CLV DETENTION & ENFORCEMENT ISOLATION CELL ADDITION
HORIZONTAL CONTROL PLAN
SHEET C-3
3 OF 15
DRAWING NO. 513-552R
12/11/15
Randy M. McConnell
CIVIL
EXP. 12/31/2015
No. 016255
PROFESSIONAL ENGINEER
STATE OF NEVADA

CLV DETENTION & ENFORCEMENT ISOLATION CELL ADDITION

TITLE CLV DETENTION & ENFORCEMENT ISOLATION CELL ADDITION		PREPARED FOR CITY OF LAS VEGAS						ADDED CONSTRUCTION PLAN SHEET FOR SAW RP AND HC PARKING STALL	
SHEET C-6.1 9 OF 15		SHEET SIDEWALK CONSTRUCTION PLAN		BID# 13.48691-TB H# 48691 DATE: MARCH 2015 DESIGNED BY: HES SUBMITTAL STAGE: FINAL DRAWN BY: HES CHECKED BY: RMM		PREPARED BY		NO.		DATE	
DRAWING NO. 513-55-2F										REVISIONS

C-4.1

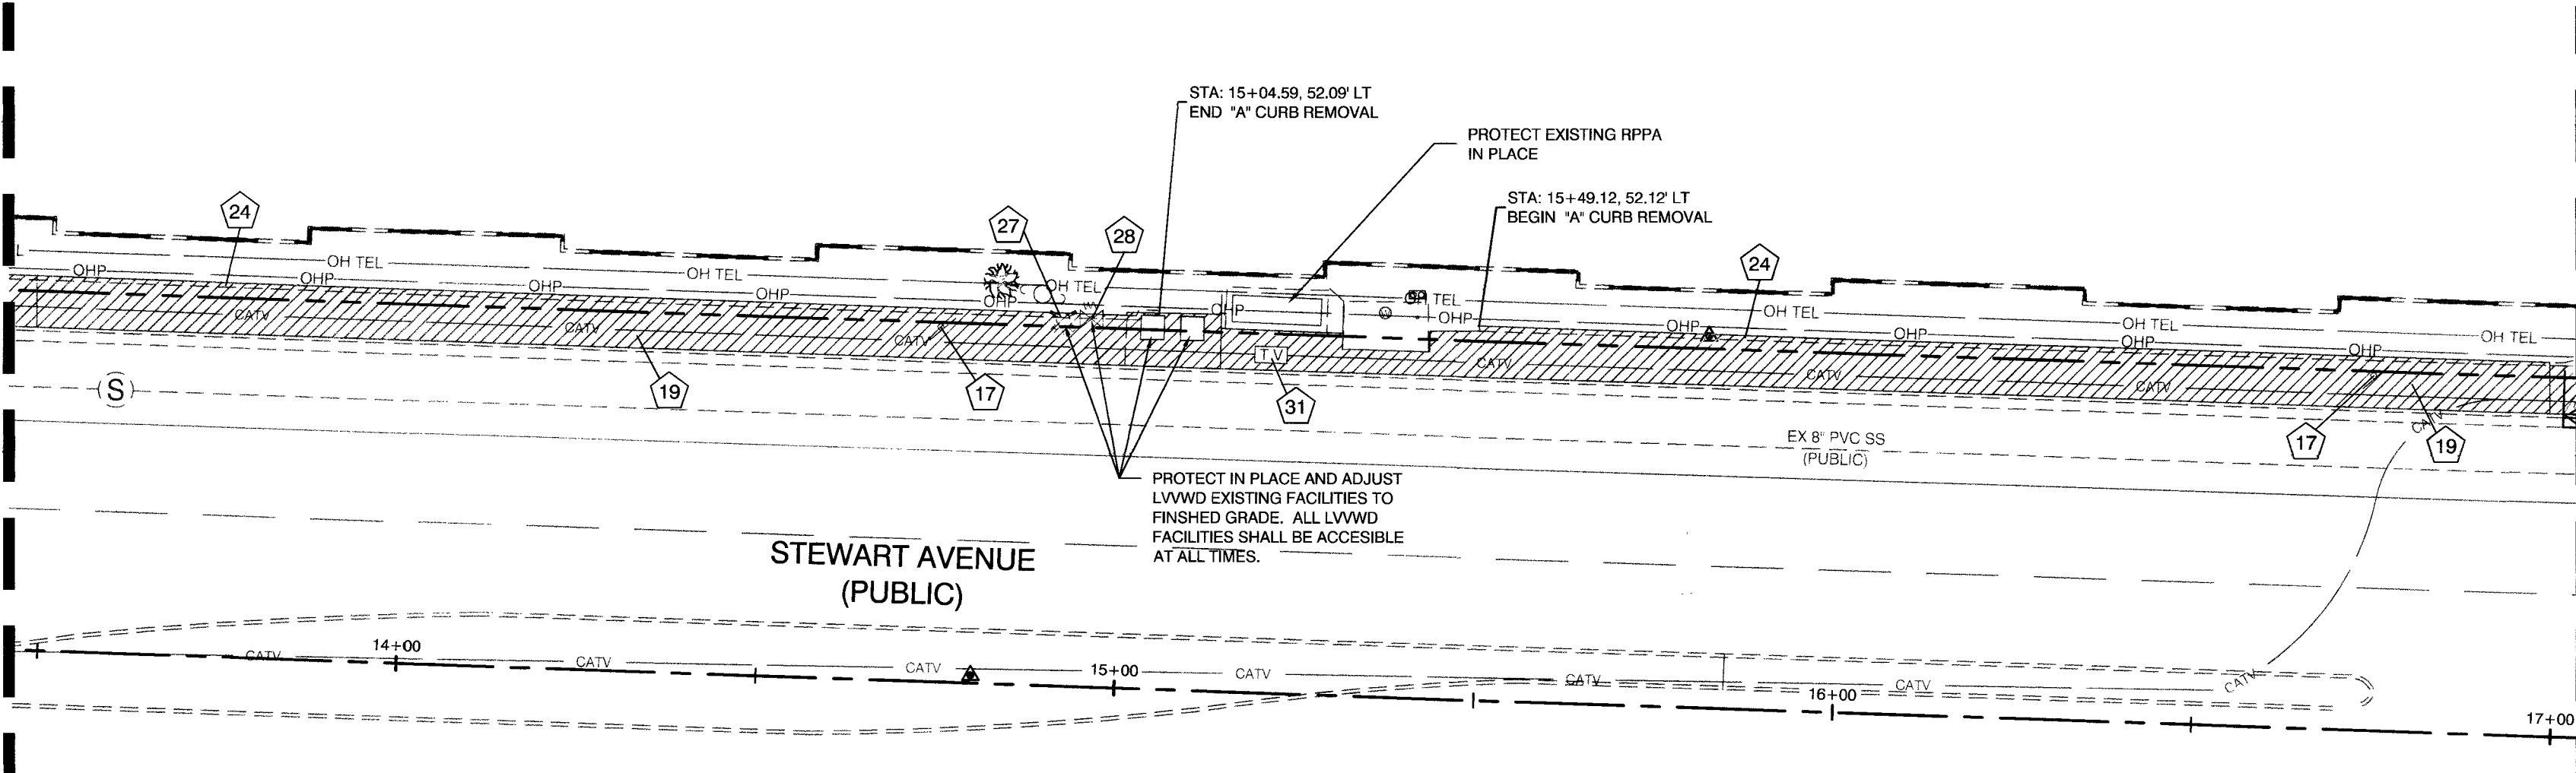
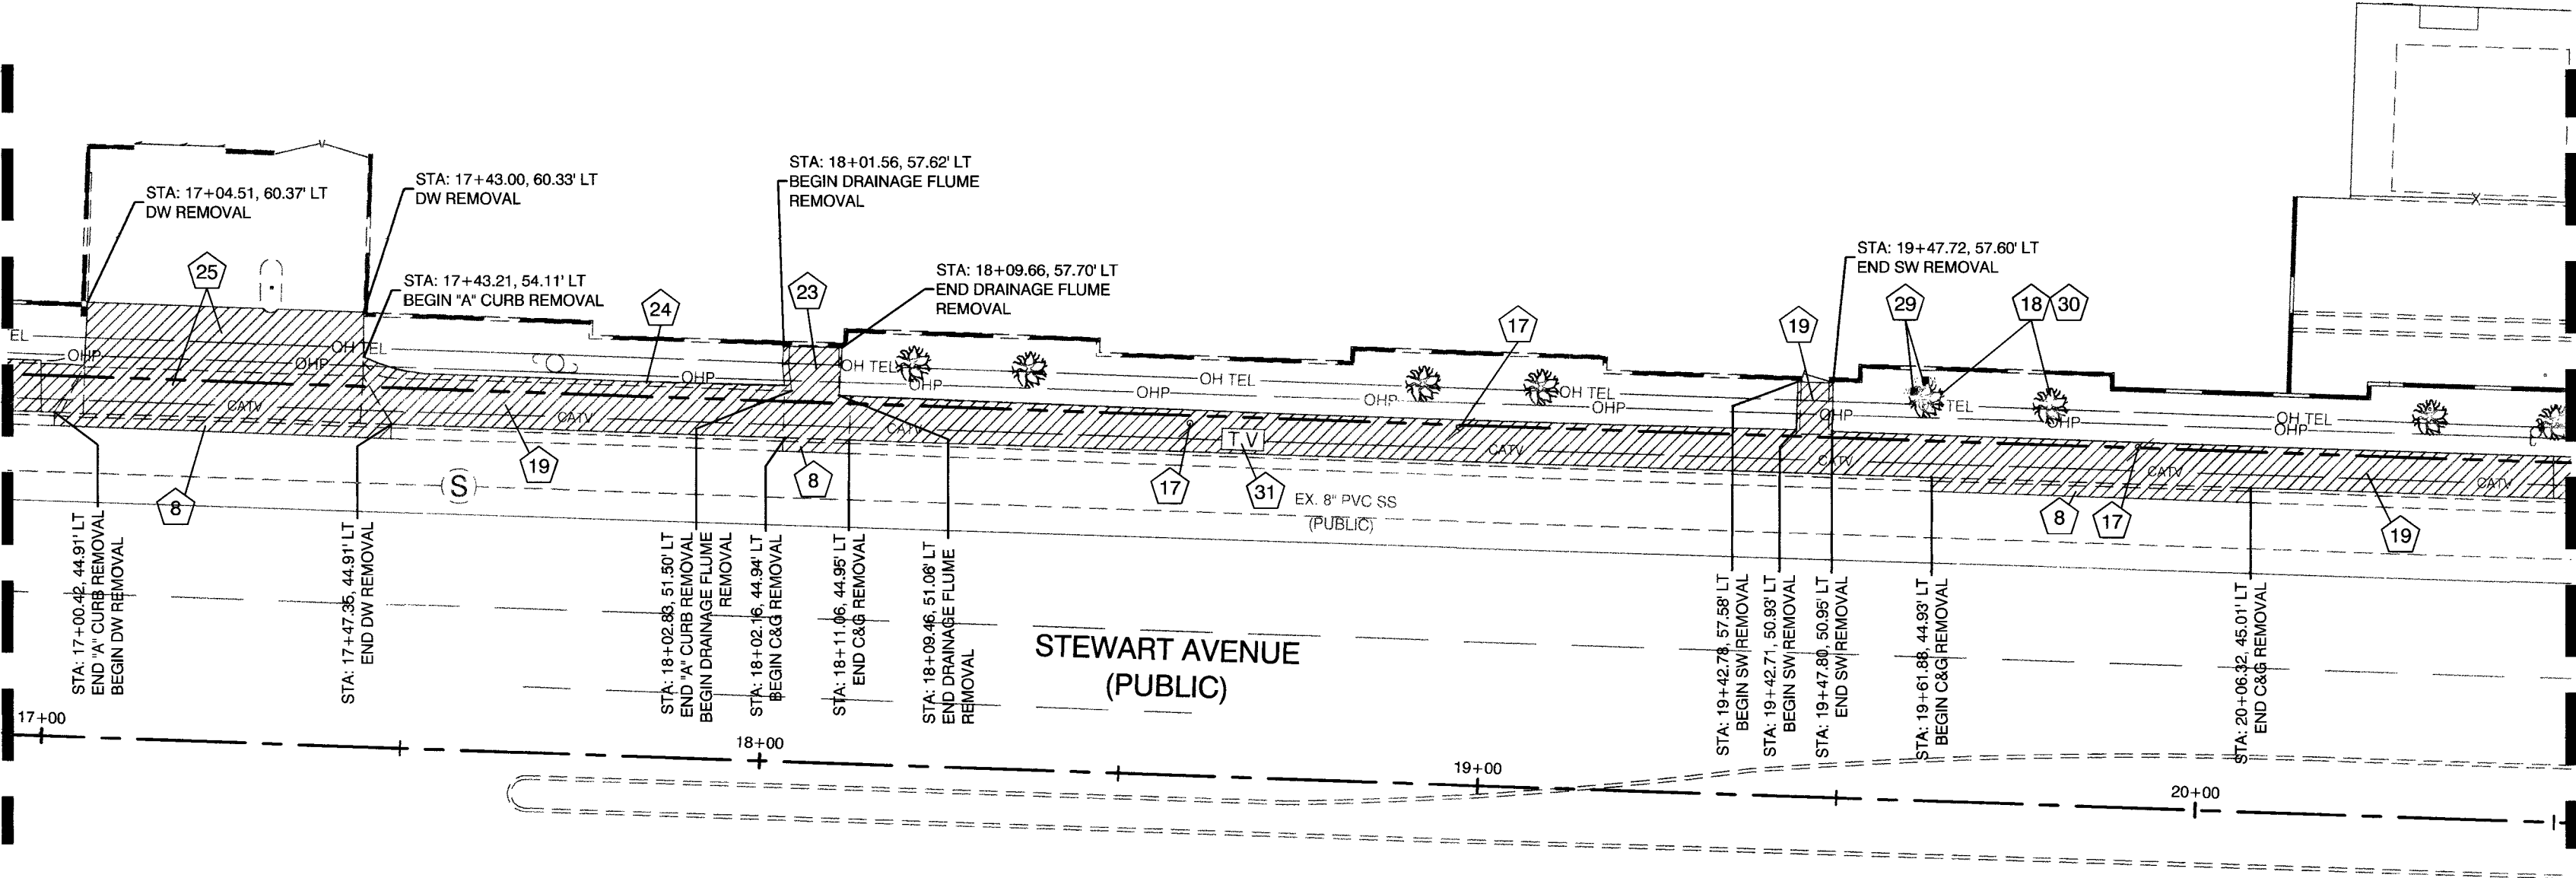
ADDED DEMOLITION SHEET FOR SW R/R

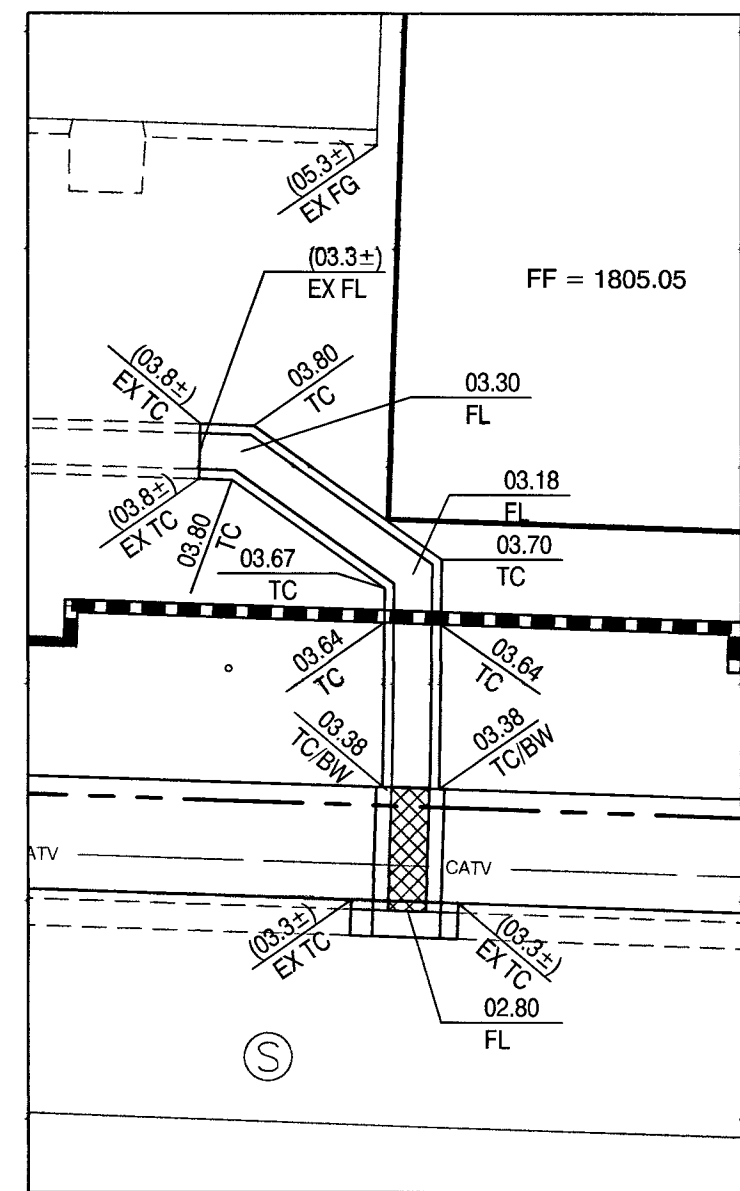
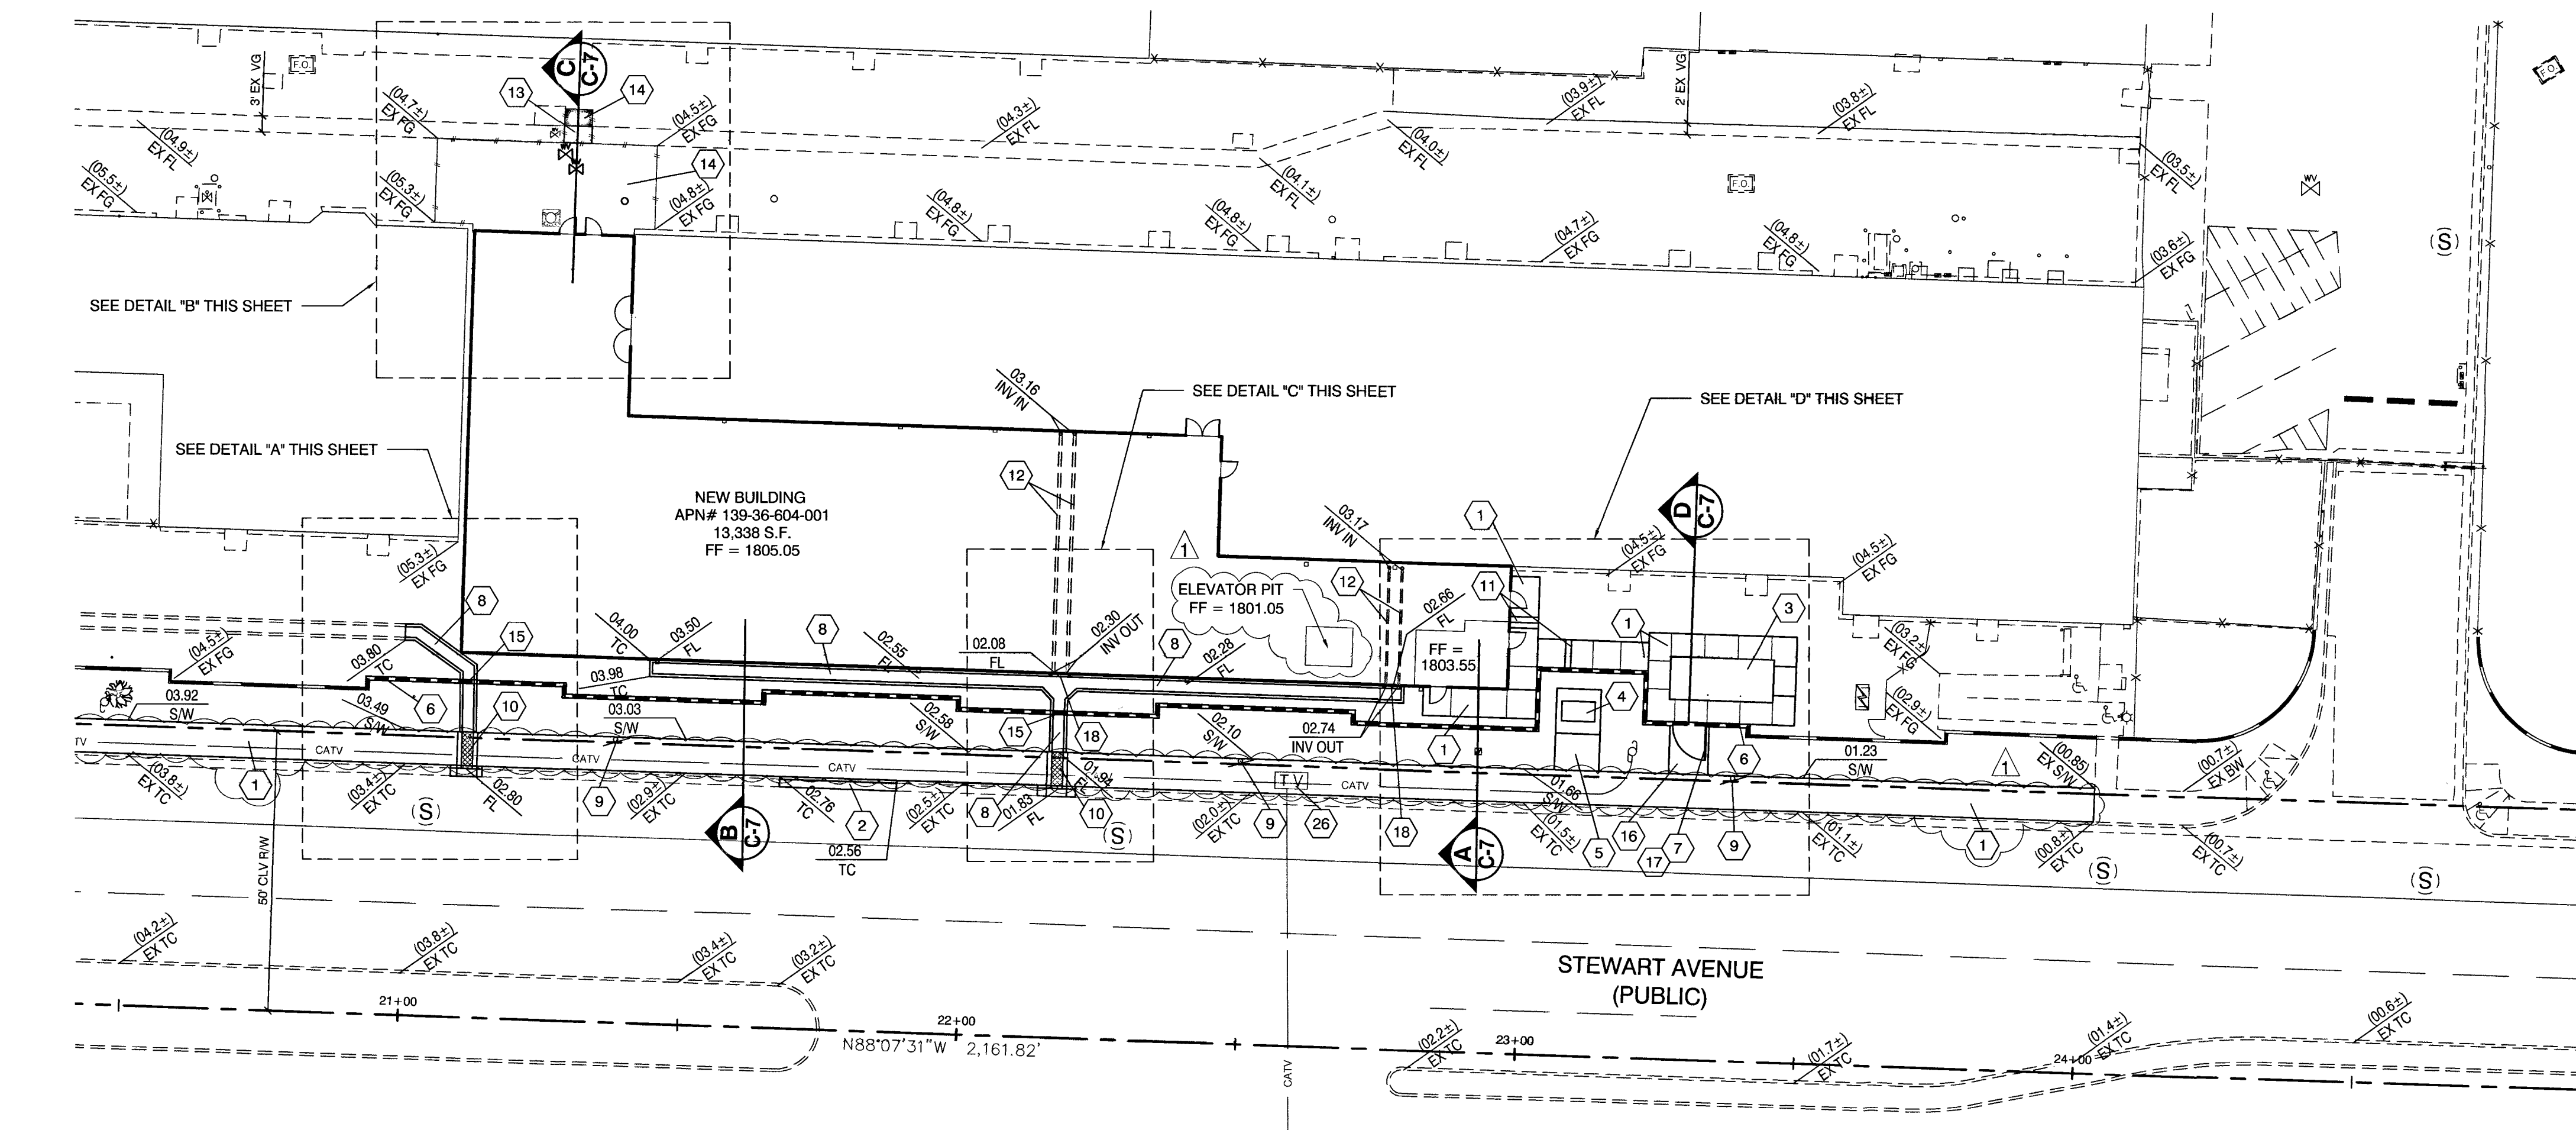
TITLE	CLV DETENTION & ENFORCEMENT ISOLATION CELL ADDITION	SHEET	UTILITY PLAN	CITY OF LAS VEGAS PREPARED FOR	CITY OF LAS VEGAS LAS VEGAS CLV DETENTION & ENFORCEMENT ISOLATION CELL ADDITION	DESIGNED BY: HES	DRAWN BY: HES	CHECKED BY: RMM	NO.	DATE	REVISIONS
SHEET	C-5	7 OF 15	DRAWING NO. 513-552R	PREPARED BY	CITY OF LAS VEGAS LAS VEGAS CLV DETENTION & ENFORCEMENT ISOLATION CELL ADDITION	DESIGNED BY: HES	DRAWN BY: HES	CHECKED BY: RMM	NO.	DATE	REVISIONS
ADDED ELEVATOR PIT FF, REVISED SHT NUMBER

F
C-7 NTS

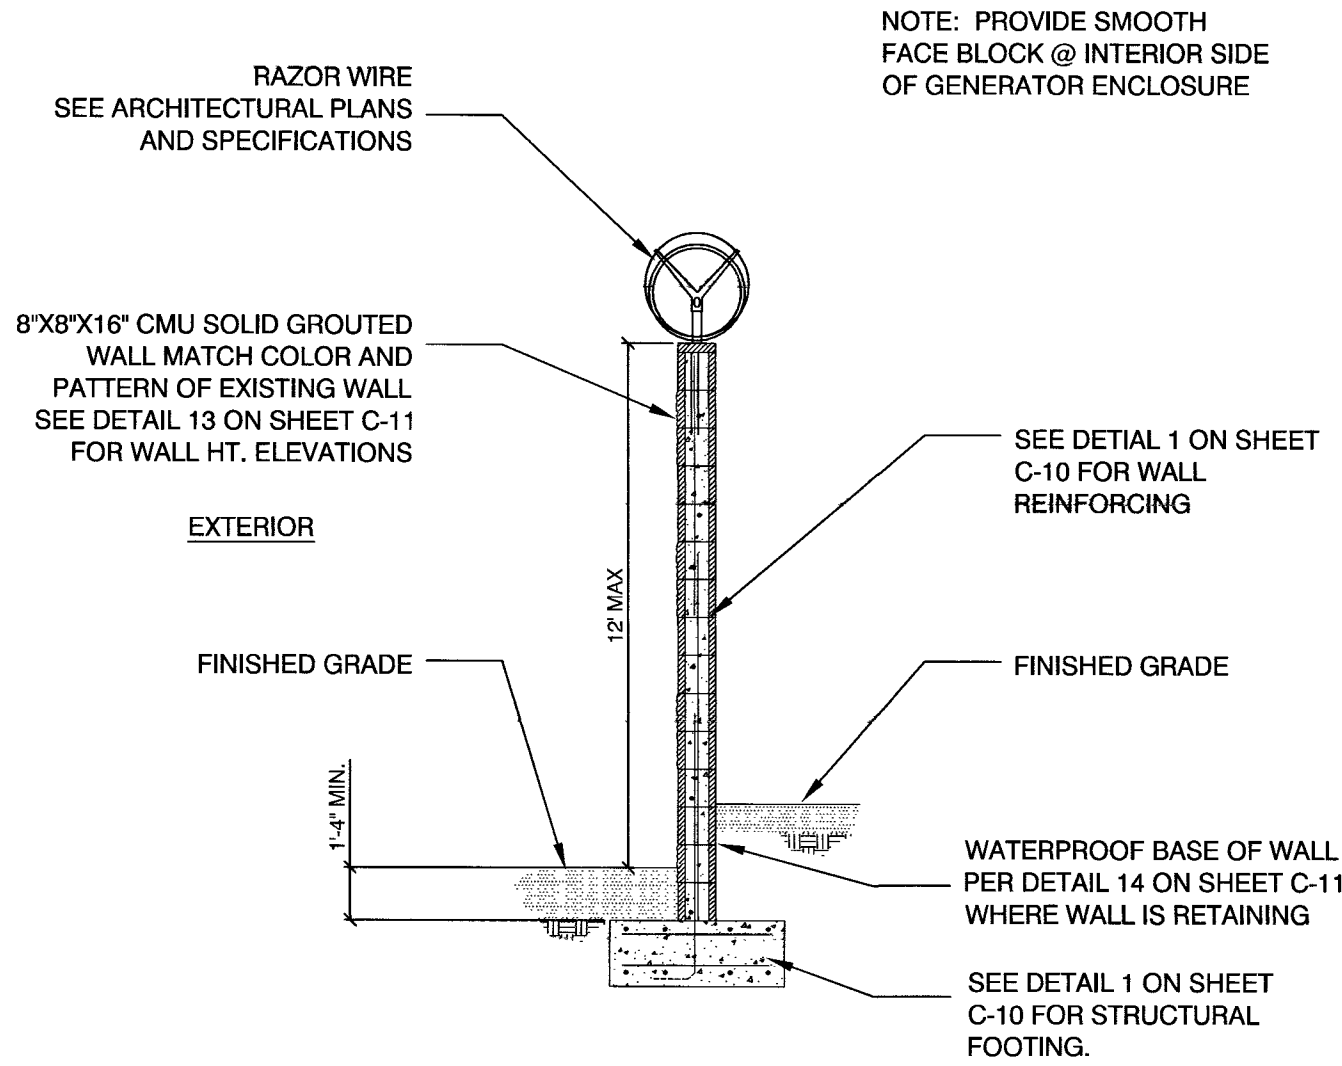
ADDED DETAILS 'E' AND 'F', REVISED SHT 4/S 08/17/15		CLV DETENTION & ENFORCEMENT ISOLATION CELL ADDITION CLV FIRE AND RESCUE NOTES AND DETAIL SHEET		PREPARED BY CITY OF LAS VEGAS		NO. DATE REVISIONS	
▲		CLV DETENTION & ENFORCEMENT ISOLATION CELL ADDITION CLV FIRE AND RESCUE NOTES AND DETAIL SHEET		PREPARED FOR CITY OF LAS VEGAS		DEPARTMENT OF PUBLIC WORKS CAPITAL PROJECT MANAGEMENT	
▲		CLV DETENTION & ENFORCEMENT ISOLATION CELL ADDITION CLV FIRE AND RESCUE NOTES AND DETAIL SHEET		H# 48891 BID# 13-48891-TB		DESIGNED BY: HES CHECKED BY: RMM	
▲		CLV DETENTION & ENFORCEMENT ISOLATION CELL ADDITION CLV FIRE AND RESCUE NOTES AND DETAIL SHEET		DATE: MARCH 2015 SUBMITTAL STAGE: FINAL		DRAWN BY: HES CHECKED BY: RMM	
▲		CLV DETENTION & ENFORCEMENT ISOLATION CELL ADDITION CLV FIRE AND RESCUE NOTES AND DETAIL SHEET		EXP. 12/31/2015 CIVIL		NO. 016256 PROFESSIONAL ENGINEER STATE OF NEVADA	
▲		CLV DETENTION & ENFORCEMENT ISOLATION CELL ADDITION CLV FIRE AND RESCUE NOTES AND DETAIL SHEET		531-55ZR DRAWING NO.		NO. DATE REVISIONS
